URGENT: MEDICAL DEVICE REMOVAL
Endoscope Reprocessor Connecting Tubes

Date: 25-MAR-2026

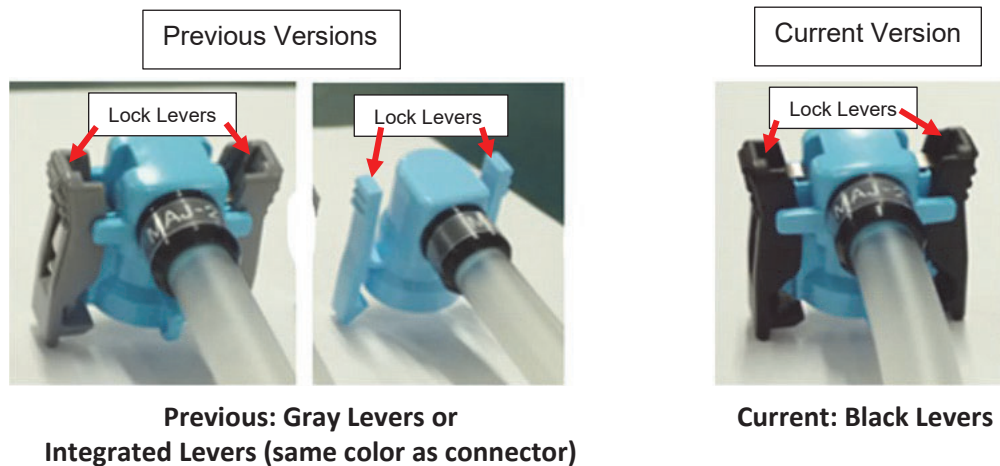
At market launch in September 2020, the initial design (Version 1) of the reprocessor connecting tube incorporated a “separate” type of connector, meaning that the connector body and the lock levers (identified in image below) were separate components. It was later identified through internal testing that the lock lever may disengage and detach from the connecting tube body if pressed outward. This subsequently led to a design change in November 2021 (Version 2) to an “integrated” type of connector, in which the connector body and lock levers are a single component. These connecting tube versions are depicted in the image below.

Olympus identified through a complaint review that Version 2 of the connecting tubes may fail prematurely. Specifically, the lock levers have detached and broken earlier than expected in some instances. The current connecting tube design addresses the issues identified for Version 1 and Version 2. Olympus will therefore be removing the previous versions of connecting tubes (Version 1 and Version 2) from the market and replacing them with the current version.

1. Examine your inventory and your OER-ELITE and identify which connecting tube version(s) you have, based on the images above. The current version has black lock levers. The previous versions have gray lock levers or integrated lock levers, which are the same color as the rest of the connector.
 - a. If you have sufficient quantities of the current version (black) to support your reprocessing needs, stop using the previous version and set aside for return. You may proceed with using the current version, only.
 - b. If you have insufficient quantities of the current version (black) available, and you do not have another method of endoscope reprocessing readily available, you may continue using the
